REVIEW OF INDIAN POINT SEVERE ACCIDENT OFF SITE CONSEQUENCE ANALYSIS

ISR Report 13014-01-01

21 December 2011

Office of the Attorney General - State of New York
120 Broadway, New York, NY 10271-0332

Figure 7: Composition of decontamination costs for plutonium [7]

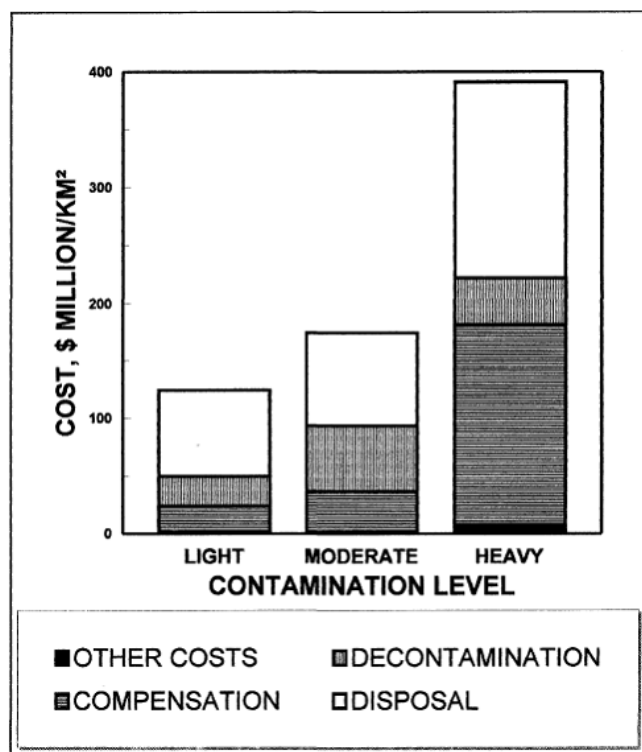
From above, NRC/Sandia is implying that characterization is a major part of the costs of decontamination.

The main cost of decontamination is not radionuclide detection/characterization, but decontamination, removal, transport and storage of waste and/or building demolition. The cost fraction of urban characterization of plutonium has been calculated by Chanin in Site Restoration [7] as less than 1 % of the total and is depicted in the graph below (see Figure 7). (Note that in the graph, characterization is included in the “other costs” category).
